Peer Review of the Living Streams Concept

David P. Hamilton, Michele A. Burford, Fran Sheldon

Australian Rivers Institute, Griffith University

City of Busselton

Figure 2 Dredging operation underway in the Lower Vasse River, May 9, 2022.

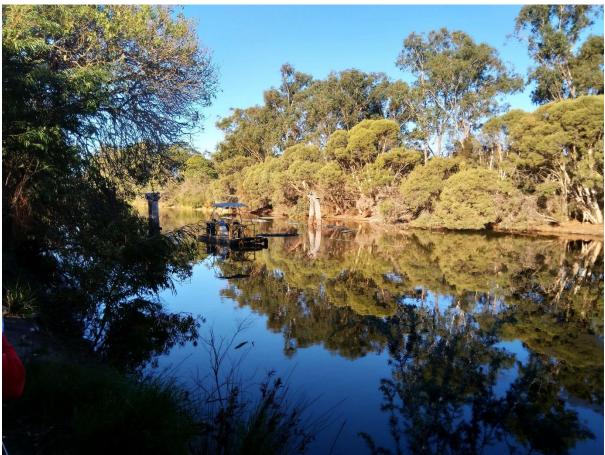
Stage 1 in the Alluvium (2020a, 2020b) report considers sediment removal by dredging the lower reach (Fig. 1) (Butter Factory weir to the old boat ramp) at an estimated cost of \$1,046,000 or dredging the whole study reach (\$2,136,000), with both costs inclusive of approvals. The reviewers endorse this approach and strongly recommend dredging the whole reach (Butter Factory weir to the Busselton Bypass) to achieve 'system-wide impacts' of removal of organic, nutrient-enriched sediments, along with appropriate mitigation actions to protect biota (e.g., Carter's freshwater mussel, endemic freshwater fish) and any unintended side effects from the dredging (e.g., sediment and nutrient resuspension, runoff from dredged spoil and spoil management). The latter effects may require supplementation with various flocculating agents (e.g., alum, polyaluminium chloride (PAC) or Phoslock[®]). The reviewers also suggest that the timing of applications of flocculating agents (likely Phoslock[®], targeted at P adsorption) be aligned with completion of dredging in sections of the LVR, i.e., soon after the dredging, to lock up P in resuspended sediments. Depending on the depth of sediment removal, there may be increased volume in the LVR to improve flood mitigation. Careful monitoring is important, particularly because it has been shown that Phoslock[®] may increase the release of ammonium under anoxic conditions (Zeller and Alperin 2021).

1) The Stage 1 dredging should be completed in full for the LVR, to address legacy issues of build-up of organic matter and nutrients in the bottom sediments. Associated with the dredging should be use of a flocculant (e.g., Phoslock[®]) to (a) offset localised effects of the dredging operation (resuspended sediments, spoil supernatant and spoil itself) and (b) be part of a plan to inactivate phosphorus throughout the LVR including releases from the bottom sediments.
